UNITED STATES PATENT AND TRADEMARK OFFICE

Office Action Summary	Application No. 10/578,408	Applicant(s) SUZUKI ET AL.	
	Examiner ADAM A. ARCIERO	Art Unit 1795

BATTERY

Examiner: Adam Arciero S.N. 10/578,408 Art Unit: 1795 May 21, 2009

FIG.36

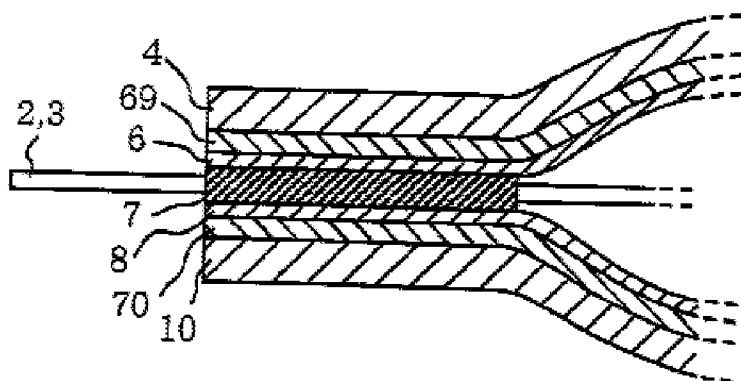
As to Claims 12, 17, 22 and 27, HANAFUSA et al. discloses a battery comprising a cathode, an anode and a separator (power generating element) accommodated in a battery case (Abstract). Said battery case is composed of a sheet comprising a laminate of an aluminum foil **69,70** and a resin layer **4,10** (pg. 1, [0006] and pg. 12, [0220] and Fig. 36). A cover member **6,8** is provided between said power generating element and said battery case. Said cathode and anode comprise respective lead terminals **2,3** (Fig. 36). Said cover member **6,8** comprises two covers **6,8** which face each other (superimposed) thereby holding a lead terminal **2,3** between them (Fig. 36).

As to Claim 13, HANAFUSA et al. discloses two cover members **6,8** which cover said power generating element, said cover members are cup-shaped and open sides of said cover members face each other (Fig. 36).

As to Claim 14, HANAFUSA et al. discloses lead terminals for the cathode and anode **2,3** (Fig. 36).

As to Claim 15, HANAFUSA et al. discloses wherein said power generating element is entirely covered with said two cover members **6,8** in said battery case (Fig. 36).

As to Claim 23, HANAFUSA et al. discloses wherein said cover members are cup-shaped, encompassing said power generating element (fig. 36).

As to Claim 24, HANAFUSA et al. discloses wherein said anode and cathode comprise lead terminals **2,3** which are held between said cover members (Fig. 36).

As to Claim 25, HANAFUSA et al. discloses wherein said power generating element is entirely covered with said two cover members (Fig. 36).

As to Claim 28, HANAFUSA et al. discloses wherein said two cover members are cup-shaped and said open sides face each other (Fig. 36).

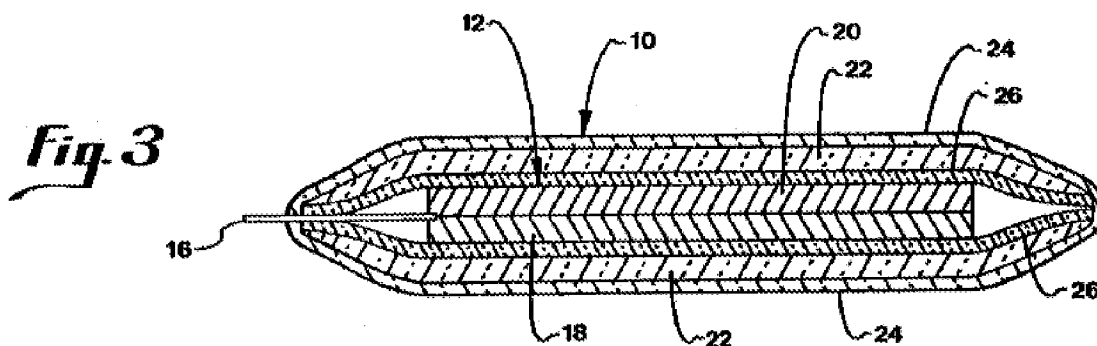
As to Claim 18, HANAFUSA et al. teaches that said covers **6,8** encompass (cup) the power generating element, therefore said covers **6,8** are cup-shaped (Fig. 37).

As to Claim 20, HANAFUSA et al. teaches the battery according to claim 18, wherein open sides of said two covers **6,8** face each other, while holding said lead terminal **2,3** between them (Fig. 37).
